Project Name: 52 N Swinton Avenue (2020-091)

Request: Certificate of Appropriateness

HISTORIC PRESERVATION BOARD STAFF REPORT

Meeting	File No.	Application Type
February 5, 2020	2020-091	Certificate of Appropriateness – Color Change

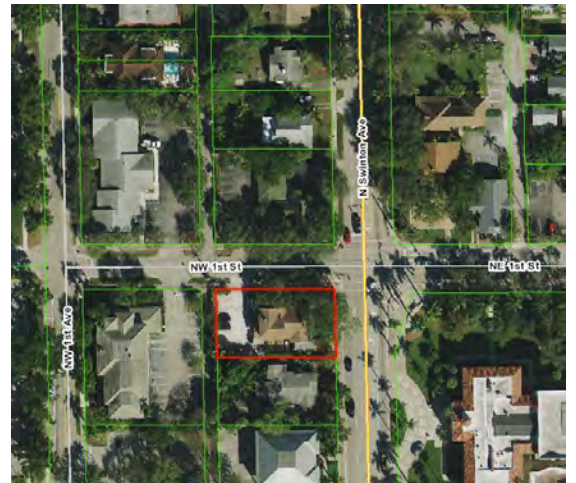
The proposal involves changing the color of the exterior of the building from a light green and cream with white trim to a red (1009-6 Jazzy Red) with white trim (7006-24 Ultra White).

In relation to Visual Compatibility Standard #7 - Relationship of Materials, Texture, and Color of a building, the façade shall be compatible with predominant materials used in historic buildings and structures within the district. The subject structure is a Craftsman Bungalow, a style that was prominent from 1905 to the 1930s. Typical color palettes used during this era focused on a variation of colors ranging from neutral to blush tones, light cremes, greens and blues, to deep jewel tones. An exterior color palette that includes two to three colors was typical for Bungalow style structures and historically, deep rich red hues have been used as both the main exterior and accent/trim colors for this style of architecture. The proposed color scheme will provide for an update that will revive the structure with little physical alteration, is seen to be compatible with the period style of architecture and will be visually compatible with the Old School Square Historic District.
